Access Compliance Report

(Curb Ramps)

Intersection ID: 10032938	Main Street: NEW_BERN_ST	Cross Street: N/A	Location: SW
ADA ID: 69FEE6D5A8EE	Ramp Type: Perp	Initial Pass/Fail: Fail	Overall Compliance: No
Severity Score: 12.5			
Codes/Mitigation Info/Possible Solution		Field Measurements/Component Compliance

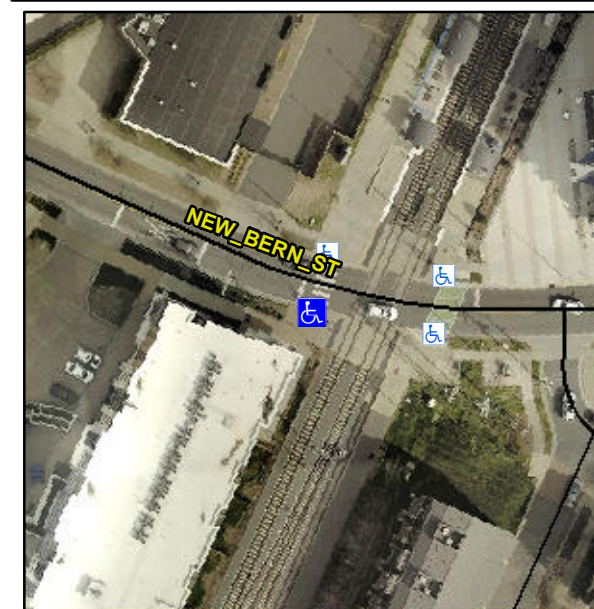
Not Found, R304.5.3

Compliance	Description	Data	Compliance	Description	Data
N/A	Ramp Length (in)	48.0	Yes	Ramp Slope (%)	5.8
Yes	Ramp Width (in)	48.0	No	Ramp XSlope (%)	6.9
N/A	Flare Type LT	N/A	N/A	Flare Type RT	N/A
N/A	Flare Slope LT (%)	N/A	N/A	Flare Slope RT (%)	N/A
N/A	Flare Traversable LT?	N/A	N/A	Flare Traversable RT?	N/A
N/A	Landing Length (in)	N/A	N/A	DWS Provided?	N/A
N/A	Landing Width (in)	N/A	N/A	DWS Contrast?	N/A
N/A	Landing Slope (%)	N/A	N/A	DWS Length (in)	N/A
N/A	Landing X Slope (%)	N/A	N/A	DWS Full Width?	N/A
N/A	Landing Curb? (Y/N)	N/A	N/A	DWS Offset (in)	N/A
N/A	Shared Landing?	N/A			
N/A	Gutter Ponding?	N/A	N/A	Gutter Slope (%)	N/A
N/A	Gutter Lip Ht (in)	N/A	N/A	Gutter X Slope (%)	N/A
N/A	Painted X Walk1?	Yes	N/A	Painted X Walk2?	N/A
	X Walk 1 Direction	To NE		X Walk 2 Direction	N/A
N/A	X Walk 1 Width (in)	119.0	N/A	X Walk 2 Width (in)	N/A
	X Walk 1 Slope (%)	1.2		X Walk 2 Slope (%)	N/A
	X Walk 1 X Slope (%)	3.5		X Walk 2 X Slope (%)	N/A

Remove & Replace Entire Ramp.
